DELEGATED APPLICATION REPORT

App Ref: PL/25/0202 Prior approval Part 3 Class MA: Commercial, business and service uses to dwellinghouses

Address: ABBEY GARDENS, 4-6 ABBEY STREET, READING, RG1 3BA

Proposal: Change of use of part of ground, first, second, third, fourth and fifth floors from Class E (offices) to C3 (dwelling houses) to comprise 84x1 bed and 8x2 bed flats. Prior Notification under Class MA, Part 3 of Schedule 2 of the Town and Country Planning (General Permitted Development) Order 2015.

310 P03 Plan of proposed ground floor showing proposed residential units with offices on either side

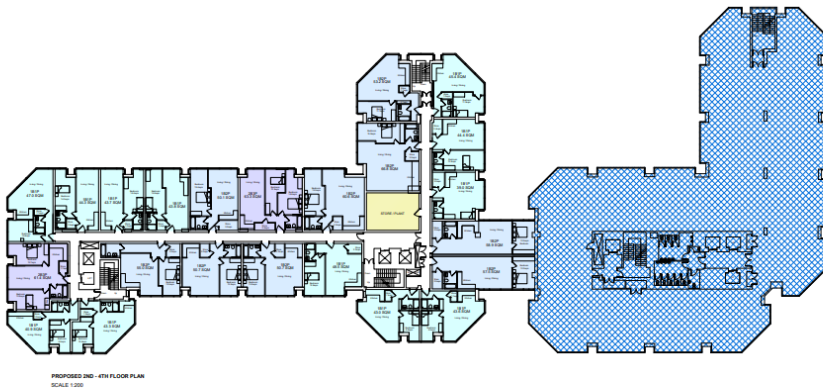
- 2.1 The Proposed Ground Floor Plan drawing shows that stair 3 (North block) connects with the commercial part of the building/floor (the existing office use). Also, the evacuation lifts associated to stair 3, serve the ground and level 1, which remain in commercial/office use, and levels 2 to 4, which are in residential use. Therefore, two different occupancies (residential and commercial) connect/communicate, and share means of escape (stair3 / lifts associated).

- 2.6 Design changes necessary to remove the connection/communication between residential and commercial parts of the building, and to provide separated means of escape may affect land use planning considerations such as the design, layout, and appearance of the development if the issue cannot be resolved with only internal alterations. It will be for the applicant to demonstrate compliance at later regulatory stages and seek advice from the LPA about the materiality of any design changes proposed.

of issues relating to fire safety and building control that will need to be addressed with the Building Safety Regulator (BSR). The building will need to be registered with the BSR on occupation. Amended plans have been submitted to overcome the issues raised in supplementary information provided by the HSE.
